U. S. NUCLEAR REGULATORY COMMISSION

Report No. 50-461/85032(DRP)

Facility Name: Clinton Power Station

Inspection on May 29 through July 9, 1985 (Report No. 50-461/85032(DRP))

FIG. NB-4427-1a FILLET WELD DIMENSIONS (CONT'D)

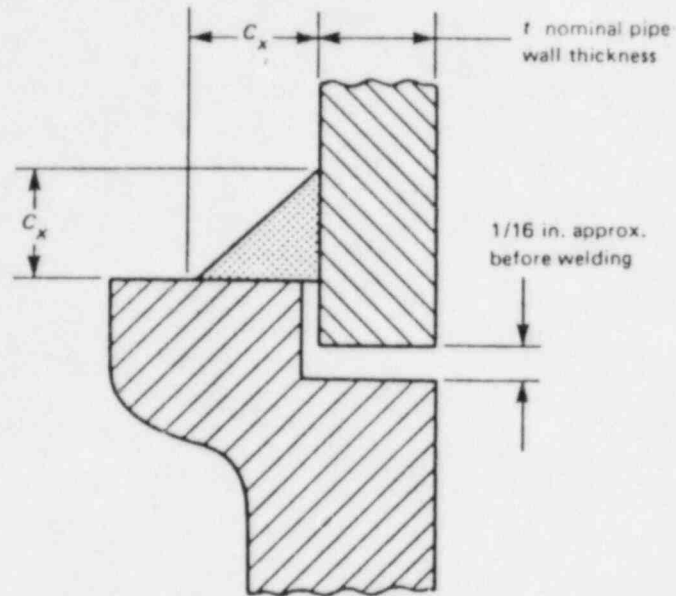
- (1) ASME Code (refer to Figure 1-A attached): The code specifies that the piping will be withdrawn approximately $1/16$ " from the socket bottom prior to welding. The code was not specific on the angularity of the piping.
- (2) BAP 2.6, Instrumentation, Section 5.6.1(e) states "for socket weld joint an approximate $1/16$ " gap shall be maintained between the end of the pipe and the bottom of the socket."

The procedure further states "the tack weld shall be made after the pipe and socket are pulled apart $1/16$," and the scribemark which should be $1/16$ " from the edge of the socket end shall be verifiable by the TS inspector." The procedure, as is the code, is not specific on angularity in pipe to socket weld fittings.

- (1) The socket weld fittings must be in accordance with ANSI B16.11. This requires that no grinding is done on the ID of the socket.
- (2) The pipe wall thickness where the pipe extends beyond the socket must be .875T nominal or greater.
- (3) The pipe insertion must be such that approximately 1/16" end gap exists prior to welding. In all cases, the pipe end must be within the socket.
- (4) The weld must be of the full required size.

FIGURE 1b

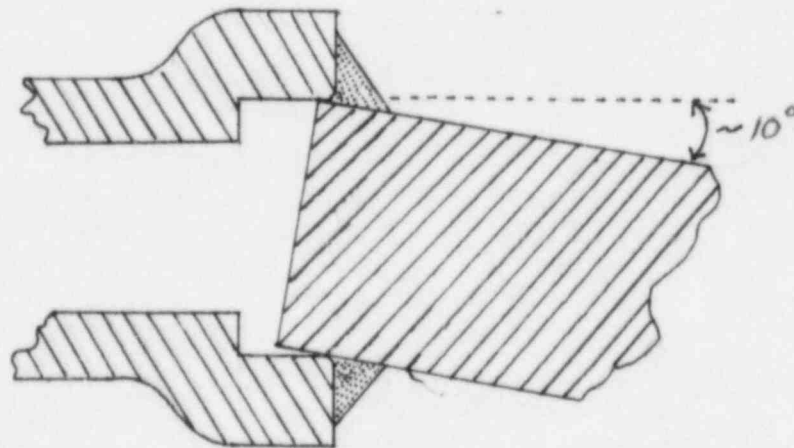
The inspector observed approximately 150 instrumentation piping installations. The piping had various angularities to eliminate the need to bend the piping for fit up. In one case, the angularity was approximately 10 degrees (Figure 1-B attached).

At the request of the inspector, the fitting in Figure 1-B (see attached) was radiographed and full piping engagement into the socket was verified. The inspector questioned whether piping with an angularity of 10 degrees or greater could bind within the socket and thereby induce excessive stresses on the weld resulting in cracking, a condition similar to weld cracking if the piping is fully engaged at the socket bottom when welded.

- (1) Will socket weld fit up with angularity approaching 10 degrees compromise the integrity of the socket weld by "bottoming out" the pipe in the socket (similar to a fully engaged socket) thereby resulting in potential cracking of the weld during the weldment cooling/solidification process? The inspector noted that the socket welds in question were generally ASME Class 3 which do not require nondestructive examination (other than a final visual inspection).
- (2) What is the source document (code or standard) which permits angularity greater than the normal tolerances of piping inserted into the socket?

These matters are unresolved pending review of the applicant's response to the above questions. The applicant agreed to provide the necessary answers. Unresolved item (461/85032-02).
